MEMORANDUM

To: Planning Board
From: Lauren A. Wasilauski, Open Space & Stewardship Director
Date: October 16, 2023
Re: PB-03-23: Harlingen Associates, LLC
Block 6001 Lots 33, 34, 34.01, 35, 35.01, 36 (Route 206)
Preliminary & Final Subdivision & Site Plan

Red line represents approximate alignment of proposed force main. A significant amount of trees will be removed if the force main is located through the Township's basin. Nearmap May 15, 2023 image.

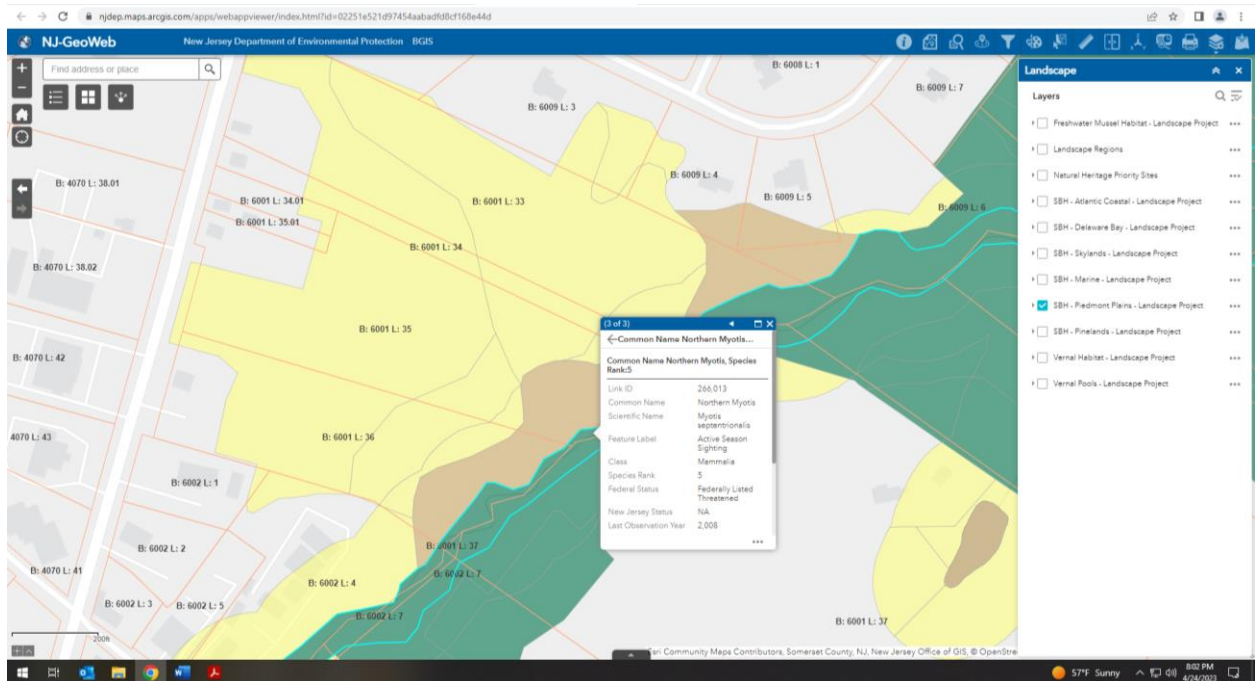
- a. This area was protected by a conservation easement at the time of a previous Planning Board approval and directed to be protected in its natural state due to the valuable resources present. Trenching through these areas to install a force main, and then continuing maintenance to keep the area clear of trees and brush to protect the integrity of the pipe will impact these areas and cause fragmentation of habitats for plant and animal communities and likely result in the proliferation of invasive species.

"8. Although the conservation and drainage easements granted and intended to be granted hereby, have been created for the benefit of the general public through the protection of water and land resources and natural beauty..."
 - c. When weighing the alternatives, the Board should consider whether the ability of 54 residences connecting to sewer is a significant enough benefit to warrant effectively nullifying a conservation easement, cutting dozens of trees, and creating permanent disturbance to habitat.

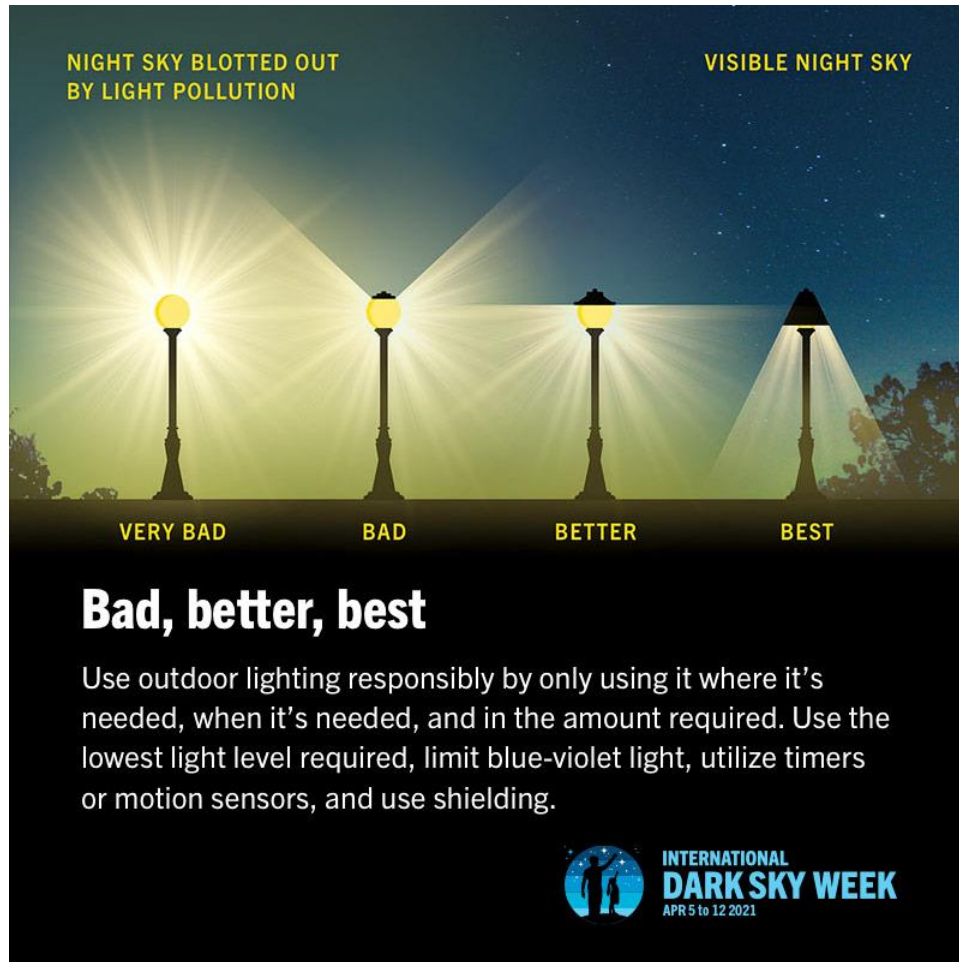
1. On sheet 12, a property entrance sign and apartment entrance sign are shown with details for lighting.
 - a. Since the time of the Site Plan Subdivision Committee, the Applicant has revised the plans to incorporate lighting that is directed downward. The notes also indicate that shields will be added and the color temperature will be no greater than 3000K. These notes are acceptable to this office, and we appreciate the revisions made.
2. The lighting along the streets and around the site shown have also been revised to incorporate comments made at Site Plan Subdivision Committee. The street lighting is now Lithonia D-series size 1. The note on sheet 31 reads that external glare shield (EGSR) will be installed on all fixtures. This change is welcome.
3. The Applicant should select the lighting option that utilizes a color temperature no greater than 3000 kelvins.

4. This office recommends these specifications about shields and color temperature be included as conditions imposed by the Board should the proposal be approved.
